The Residences of South Brookline

Zoning Board of Appeals
Presentation

April 10, 2014

BETA Comments – CHR Response Presentation Format

1 POROUS ASPHALT PAVEMENT
SCALE: 1" = 1'-0"

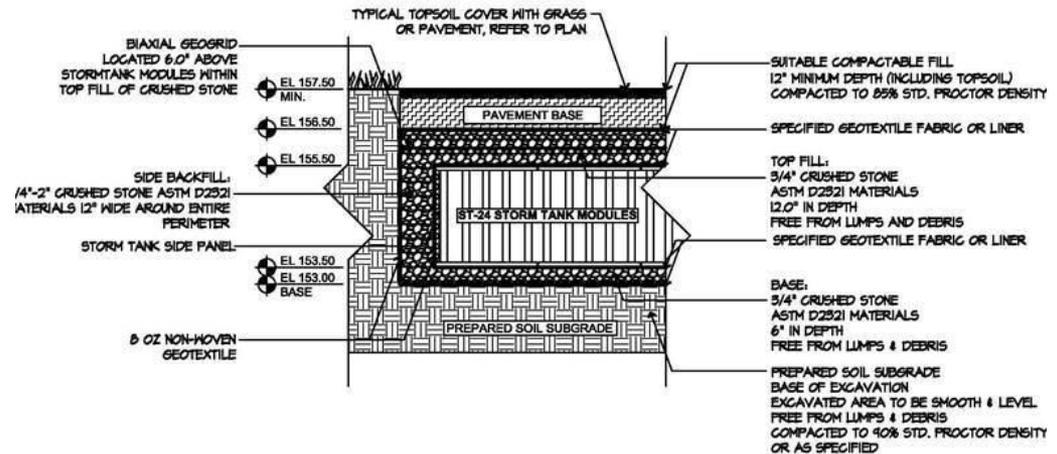
- **Porous Pavement Comments**

- **Porous Pavement Design Approach**
 - High groundwater and shallow ledge are why porous pavement is proposed
 - Allows for shallow profile, reducing the amount of filling required to achieve separation from groundwater/ledge

- Design is conservative
 - No credit taken for exfiltration
 - Specifications will be developed during Construction Documents preparation. University of New Hampshire's Stormwater Center specifications will be used as a guide. UNH is a leader in pervious pavement research.
 - Will provide precedent information and details in the working session with BETA
-
